SUMMARY AND ANALYSIS OF COMMENTS
ON THE
NOTICE OF PROPOSED RULEMAKING
FOR
REVISED GASEOUS EMISSION REGULATIONS
FOR 1984 AND LATER MODEL YEAR LIGHT-DUTY
TRUCKS AND HEAVY-DUTY ENGINES

JULY 1983

STANDARDS DEVELOPMENT AND SUPPORT BRANCH
EMISSION CONTROL TECHNOLOGY DIVISION
OFFICE OF MOBILE SOURCES
OFFICE OF AIR, NOISE AND RADIATION
U.S. ENVIRONMENTAL PROTECTION AGENCY

Figure 1-3

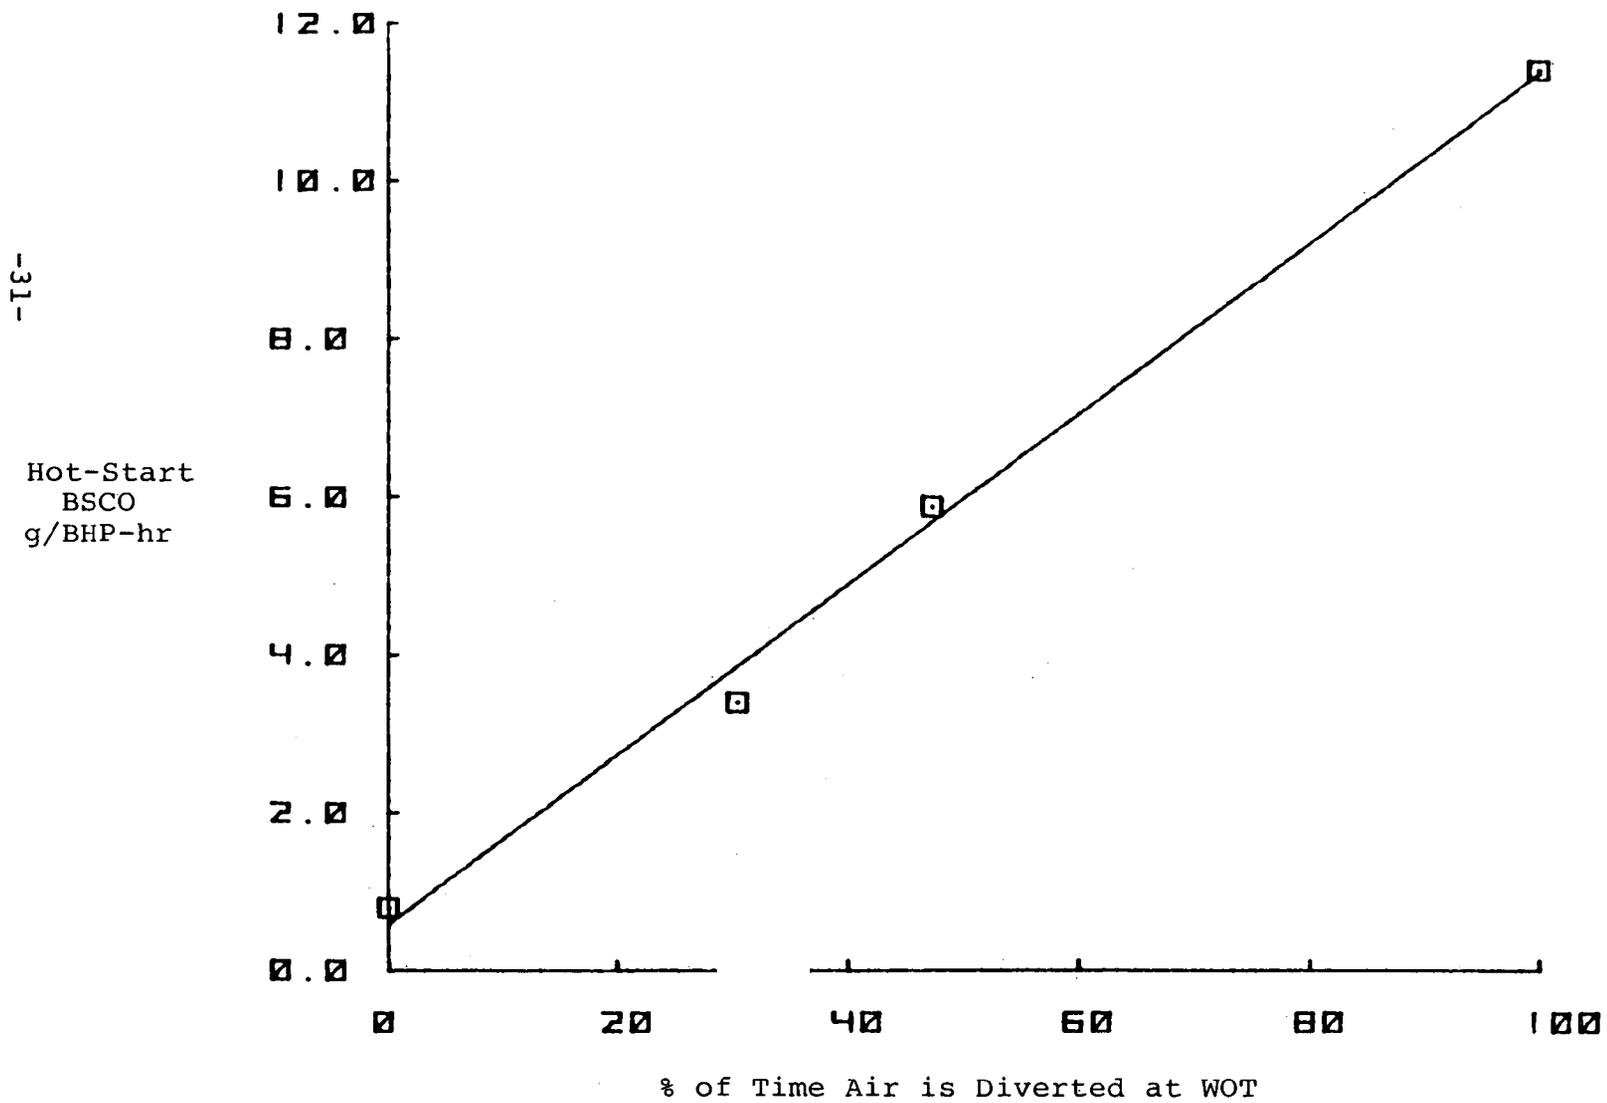
EPA's testing of the Ford 7.5L (see Table 1-8) examined the relationship between CO emissions and the injection of air to the catalyst. (Evaluations of catalyst temperatures were also made, and are discussed below with respect to catalyst protection systems.) Solenoid valves were installed in the engine's air injection system so that complete control of when air was being injected into the catalyst was achieved. Testing was conducted such that different amounts of air were added to the catalyst at wide open throttle (WOT). (WOT was defined as the condition when the manifold vacuum was equal to or less than 2 inches Hg, the point at which power enrichment was observed to substantially begin.) Figure 1-3 shows the observed trade-off between hot start CO emissions and the diverted air; Table 1-9 lists the hot start emission data. Even though WOT represents only a small amount of the total test time (4.5 percent), the CO emissions attributable to this fraction of operation are relatively high. By allowing more air to reach the catalyst, (i.e., air was injected a greater percentage of the time the engine was at WOT), there was a dramatic reduction in CO emissions. In fact, with full-time air injection, CO emissions were virtually eliminated. EPA's

This trade-off, however, is not significant enough to preclude compliance with the statutory CO standards. EPA bases this judgment on the test data discussed above, with which it was demonstrated that, for at least one engine, air injection could be completely diverted for up to 60 percent of the time spent at WOT on the transient test, and sufficiently low CO emission levels could still be maintained (see Figure 1-3 and

Figure 3-4

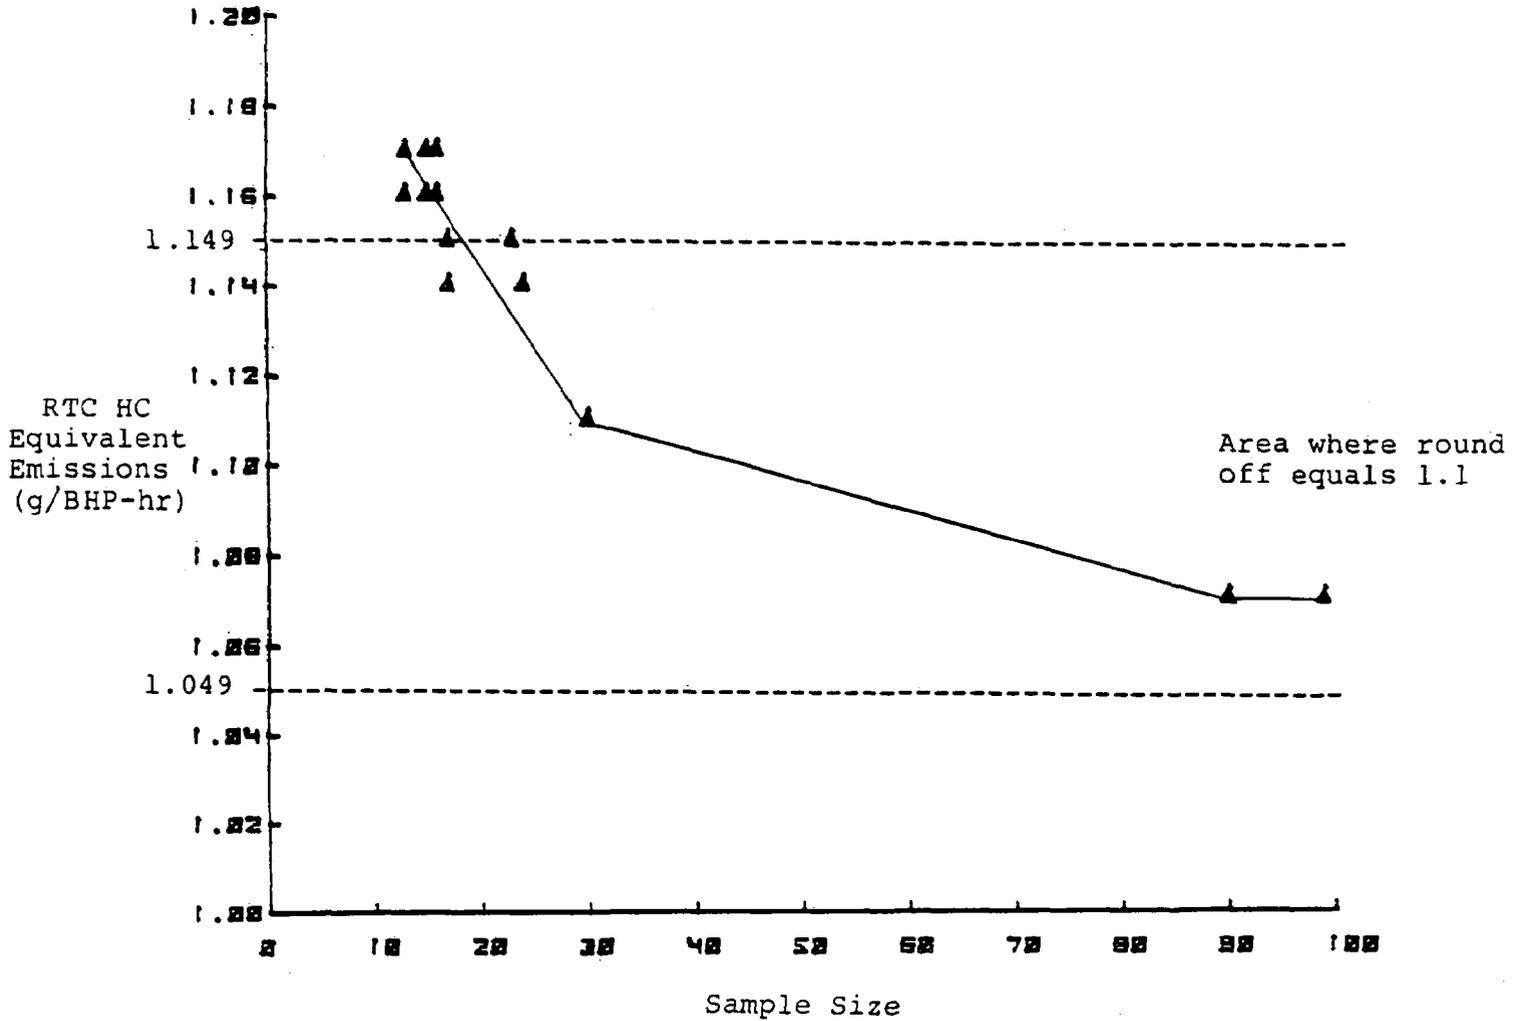
base by almost 70 percent, including the exclusion of all but one engine of the major manufacturer (Cummins Engine Company). The importance of the additional data can be seen in Figure 3-4, in which RTC HC equivalent emissions are plotted as a function of sample size. As the data base increases, the adjusted standard converges on 1.1 g/BHP-hr. Again, this may not so much be an effect of sample size, but more an effect of the inclusion of Cummins's engines in a more representative number. In short, the most accurate representation of the difference between the test cycles is derived from the larger data base; the starting condition of the engine has been demonstrated to be unimportant.

FIGURE 7-1

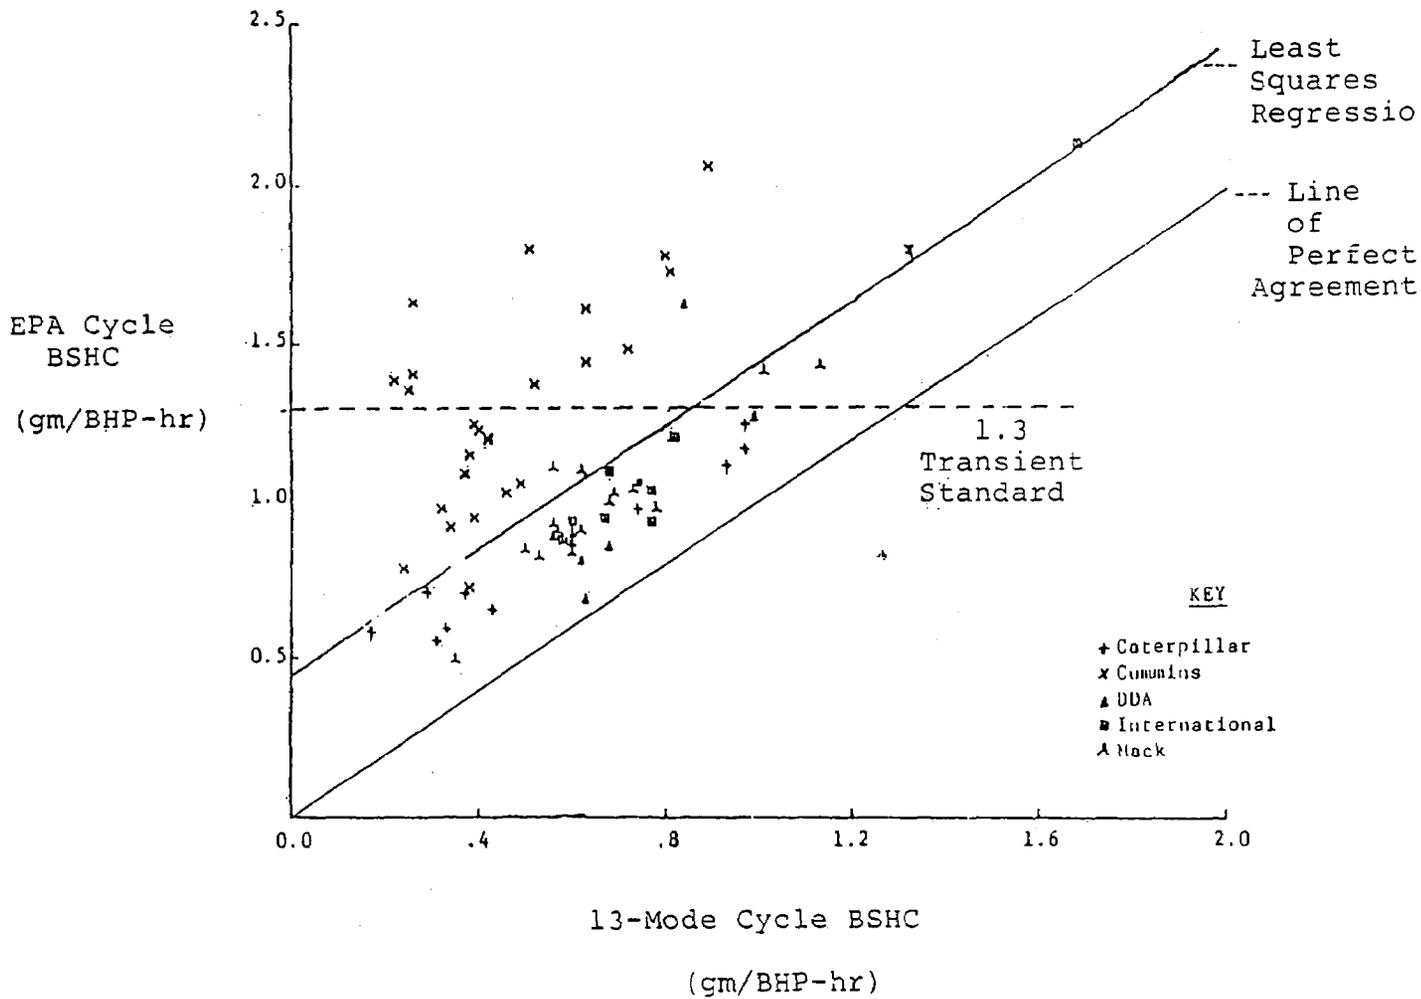
The industry has argued that a 0.5 g/BHP-hr optional 13-mode standard is too stringent, and is essentially a non-option.[1,5] As indicated by Figure 7-4 (representing the HC emission distribution of all domestic and foreign HD diesel engines certified in 1982 on the 13-mode test), as the optional 13-mode standard becomes more stringent, fewer engines can be carried over without development work and recertification. Figure 7-4 indicates that with a 0.5 standard and a full useful life, 21 percent (13/67) of 1982 engine families would be eligible for carryover. Revising the optional standard to the industry's recommended 1.0 g/BHP-hr permits 73 percent (46/67) of 1982 engine families to carryover. This would certainly provide increased flexibility for allocation of testing and development resources for both model years 1984 and 1985. (We note that these percentages do not include engines which can still be recertified on the 13-mode test in 1983, and then be eligible for carryover.) In short, EPA's acceptance of the industry's recommended optional standard would alleviate much of the recertification testing burden for 1984.

Based upon the correlation presented in Figure 7-1, however, we have little confidence that any 13-mode standard between 0.5 and 1.3 can adequately predict compliance with a 1.3 transient standard; hence, its level should be set based upon the industry's requirements for relief, not upon emission control requirements. A steady-state HC standard of 1.0

g/BHP-hr would be appropriate to provide some flexibility to the industry as they spread out recertification over an additional year. A 0.5 g/BHP-hr standard would likely yield some additional emission reductions, but not to any predictable extent. Practically, however, the relative difficulty in meeting a 0.5 g/BHP-hr standard may in fact force transient certification, which is not consistent with the relief requirements identified. A 0.5 g/BHP-hr steady-state option may actually misdirect technology from transient certification.

FIGURE 7-3

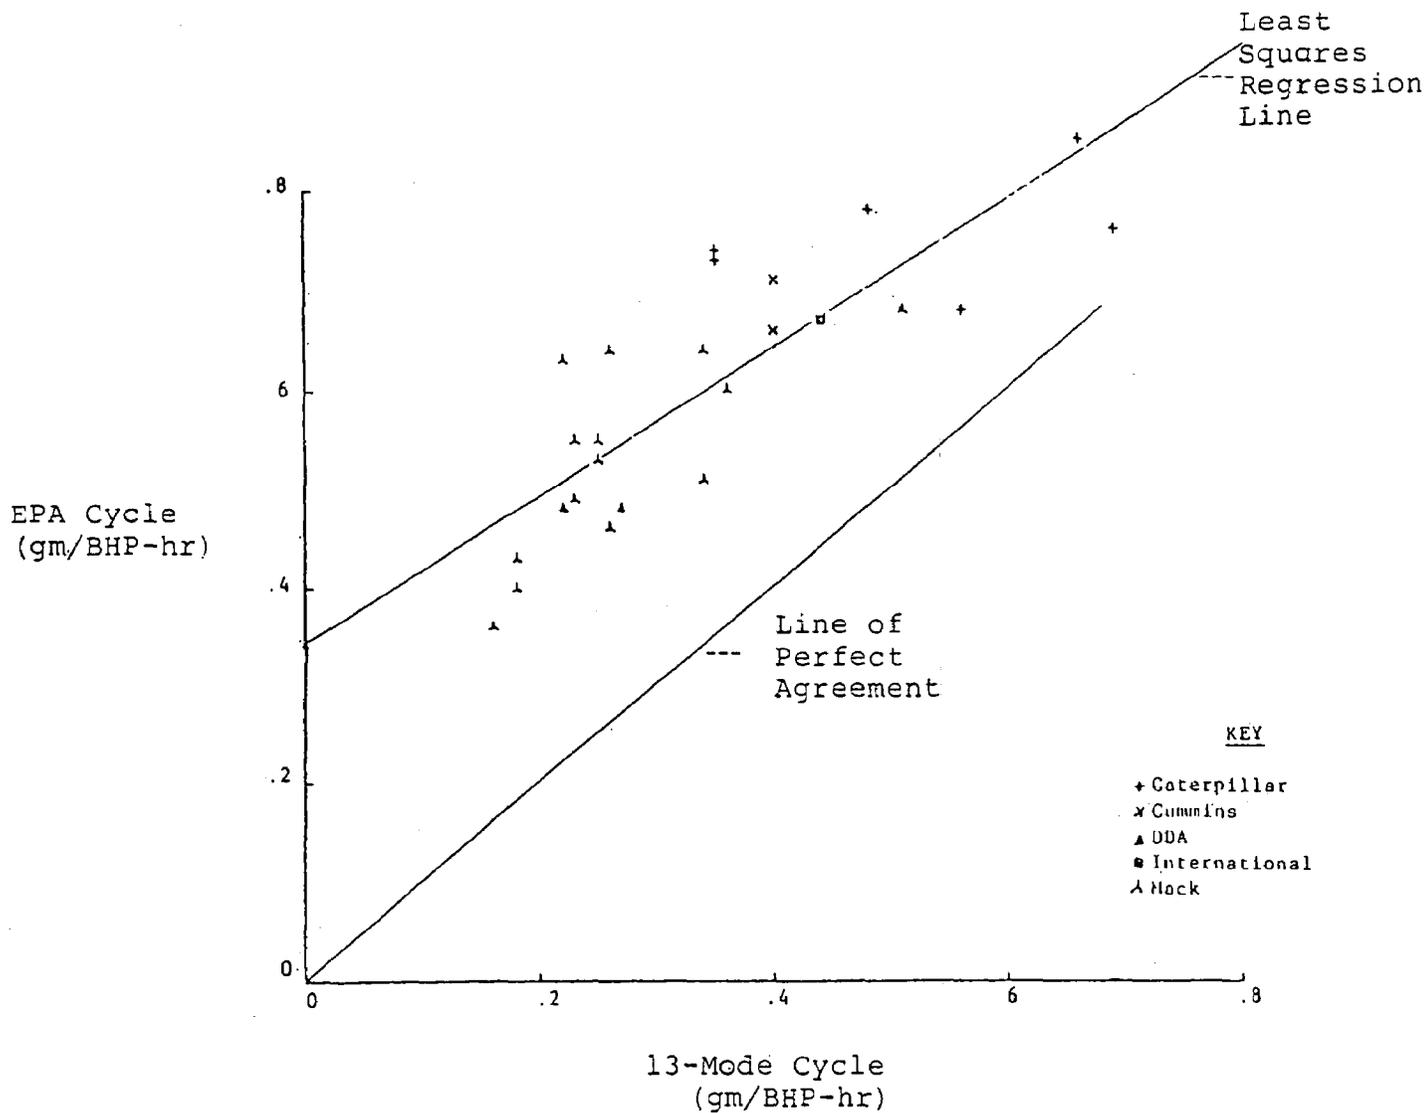
emission reductions. This is also true of the "correlation" between transient and steady-state particulates (see Figure 7-3) for which future standards will also be promulgated. The promulgation of more stringent standards (NOx and particulate) makes the use of the transient test all the more necessary to ensure that laboratory emission reductions also occur in the field. Using all available emission data, we find that the transient test is technically justifiable today, and even moreso when more stringent NOx and particulate standards become applicable.

Figure A-2: Mean %RPM Distributions of CAPE-21 Trucks (LA Freeway - Gasoline)

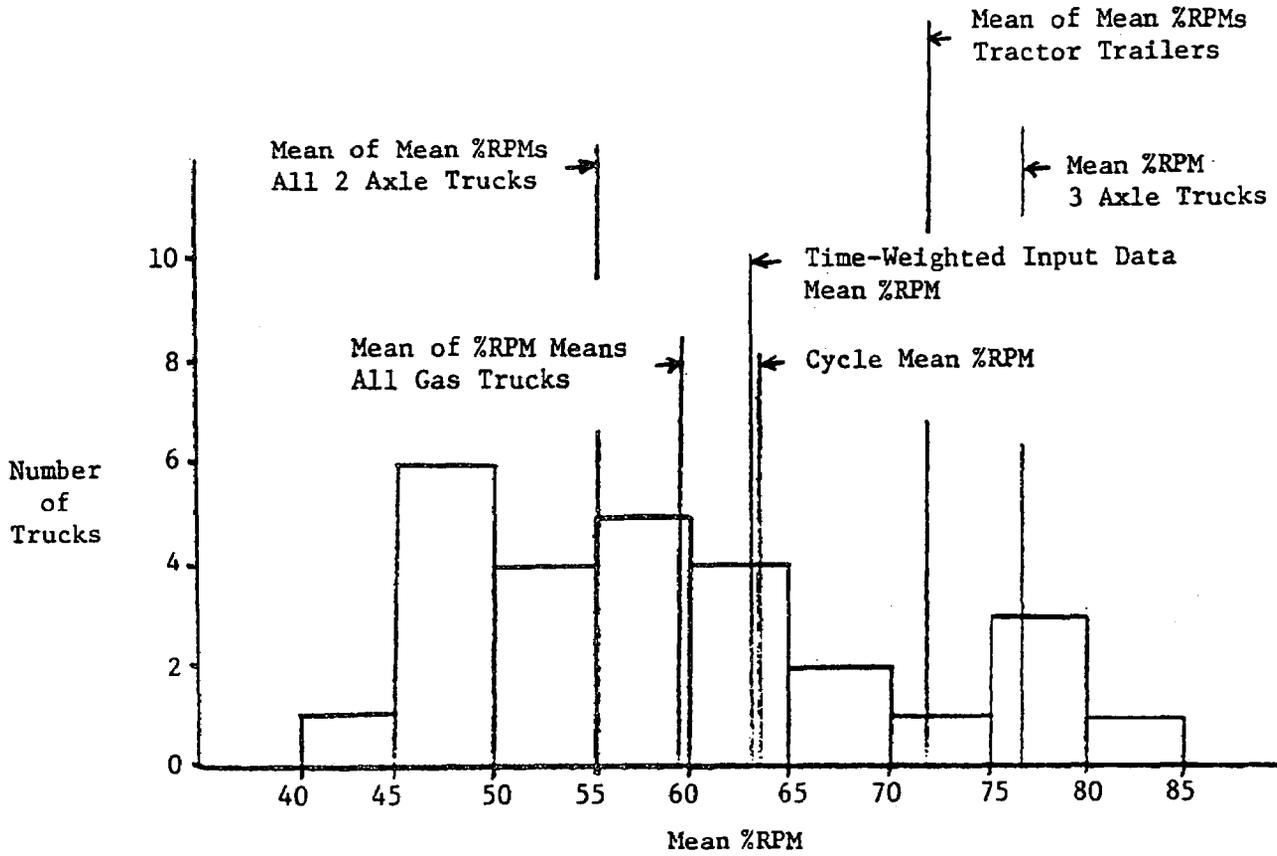
To address A.D. Little's criticism of the statistical filter methodology, it is best to review the real practical constraints on cycle generation.

Firstly, the cycles are intended to model an extremely diverse population of trucks. As a case in point, Figure A-2 shows the means of all observed percent rpm's for each individual LA gasoline truck (freeway) varying from 40 to 85 percent. The distribution of truck operational parameters about these means, and throughout the aggregate data base, is continuous and decidedly non-normal. This widely distributed, nonsymmetrical, non-normal distributional characteristic severely limits the statistical tests which can be used to quantitatively compare the population with an empirical sample. If a quantitative measure of representativeness is to be made at all (as opposed to a subjective verification using intuition and engineering judgment), only a non-parametric test is available, of which the K-S test is an applicable example. This fact is independent of the cycle generation technique.

5.3.2 E -- A.D. Little's assertion that the standard deviation of LAF rpm indicates that excessive variation is present, is judged by EPA to be explainable and inconsequential. Firstly, as indicated in Figure A-2, the actual truck mean rpm's vary so widely that we cannot see how small differences in standard deviations can be meaningful in a practical engineering sense in the first place. Secondly, A.D. Little again neglected the differential operating times of trucks, i.e., their time-weightings. Finally, referring to Figure A-11, we infer that an increased standard deviation of the LAF subcycle rpms relative to that of the input data is explainable by the above-mentioned extra time spent at higher speeds. As also discussed above, the emission impact is minimal.
